Access Compliance Report Public Rights-of-Way (Curb Ramps)

Main Street: PINEHURST_ST		Cross Street: ROLLING_RIDGE		Location:	NW
ADA ID: RPRK211019135629	Ramp Type: Type 4 - Parallel	Initial Pass/Fail: Fail	Overall Compliance: No	Severity Score:	30
Codes/Mitigation Info/Possible Solution			Field Measurements/Component Compliance

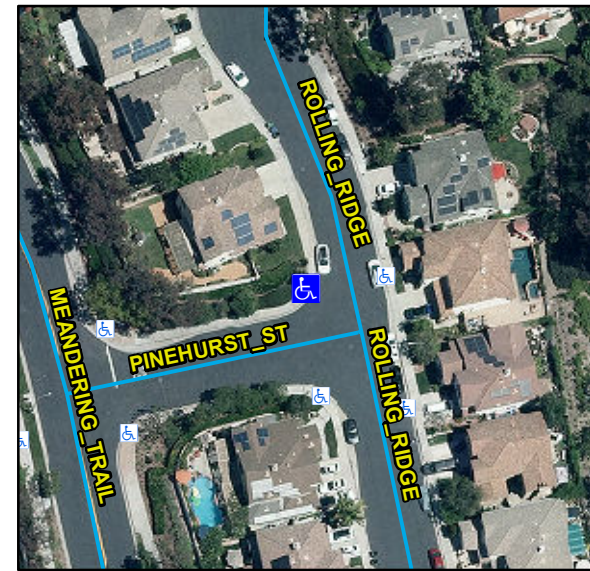
Compliance	Description	Data	Compliance	Description	Data
N/A	Ramp Length LT (in)	114	N/A	Ramp Length RT (in)	118
Yes	Ramp Width LT (in)	53	Yes	Ramp Width RT (in)	54
Yes	Ramp Run Slope LT (%)	3.9	Yes	Ramp Run Slope RT (%)	7.7
No	Ramp Cross Slope LT (%)	11.3	No	Ramp Cross Slope RT (%)	12.5
N/A	Landing Present	N/A	N/A	DWS Provided	N/A
N/A	Landing Length (in)	N/A	N/A	DWS Contrast	N/A
N/A	Landing Width (in)	N/A	N/A	DWS Length (in)	N/A
N/A	Landing Run Slope (%)	N/A	N/A	DWS Full Width	N/A
N/A	Landing Cross Slope (%)	N/A		DWS Offset Type	N/A
N/A	Landing Movement Obstructed?	N/A	N/A	DWS Offset Left (in)	N/A
	Landing Movement Type	N/A	N/A	DWS Offset Right (in)	N/A
N/A	Landing Shared	N/A			
N/A	Clear Space	Yes			
N/A	Clear Space To Crosswalk (in)	N/A			
N/A	Marked Crosswalk 1	No	N/A	Marked Crosswalk 2	No
	Crossing 1 Direction	S		Crossing 2 Direction	E
	Marked Crosswalk 1 Width (in)	N/A		Marked Crosswalk 2 Width (in)	N/A

Remove & Replace Curb Ramp With Two New Directional Ramps or Equivalent.
